# Access Compliance Report

## Public Rights-of-Way

Intersection ID: 45488	Main Street: CAPTAIN_ARDREY_RD	Cross Street: GINHOUSE_LN	Location:	E
ADA ID: 8C6EE21563F0	Ramp Type: PerpDiag	Initial Pass/Fail: Fail	Overall Compliance: No	Severity Score: 22.5
Codes/Mitigation Info/Possible Solution		Field Measurements/Component Compliance

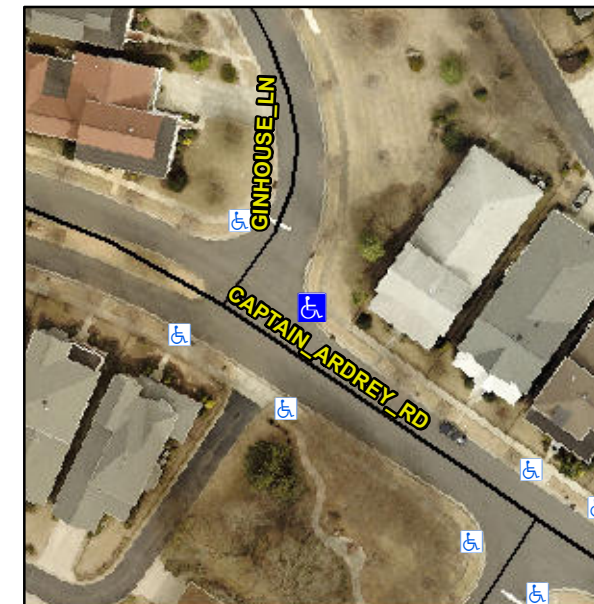
**Not Found, R304.5.1, R304.2.2, R304.5.3**

Compliance	Description	Data	Compliance	Description	Data
N/A	Ramp Length (in)	72.0	No	Ramp Slope (%)	9.5
No	Ramp Width (in)	37.0	No	Ramp XSlope (%)	2.2
N/A	Flare Type LT	N/A	N/A	Flare Type RT	N/A
N/A	Flare Slope LT (%)	N/A	N/A	Flare Slope RT (%)	N/A
N/A	Flare Traversable LT?	N/A	N/A	Flare Traversable RT?	N/A
N/A	Landing Length (in)	N/A	N/A	DWS Provided?	N/A
N/A	Landing Width (in)	N/A	N/A	DWS Contrast?	N/A
N/A	Landing Slope (%)	N/A	N/A	DWS Length (in)	N/A
N/A	Landing X Slope (%)	N/A	N/A	DWS Full Width?	N/A
N/A	Landing Curb? (Y/N)	N/A	N/A	DWS Offset (in)	N/A
N/A	Shared Landing?	N/A			
N/A	Gutter Ponding?	N/A	N/A	Gutter Slope (%)	N/A
N/A	Gutter Lip Ht (in)	N/A	N/A	Gutter X Slope (%)	N/A
N/A	Painted X Walk1?	No	N/A	Painted X Walk2?	No
	X Walk 1 Direction	To NW		X Walk 2 Direction	To SW
N/A	X Walk 1 Width (in)	N/A	N/A	X Walk 2 Width (in)	N/A
	X Walk 1 Slope (%)	4.3		X Walk 2 Slope (%)	2.9
	X Walk 1 X Slope (%)	2.4		X Walk 2 X Slope (%)	3.7

**Remove & Replace Curb Ramp With Two New Directional Ramps or Equivalent.**
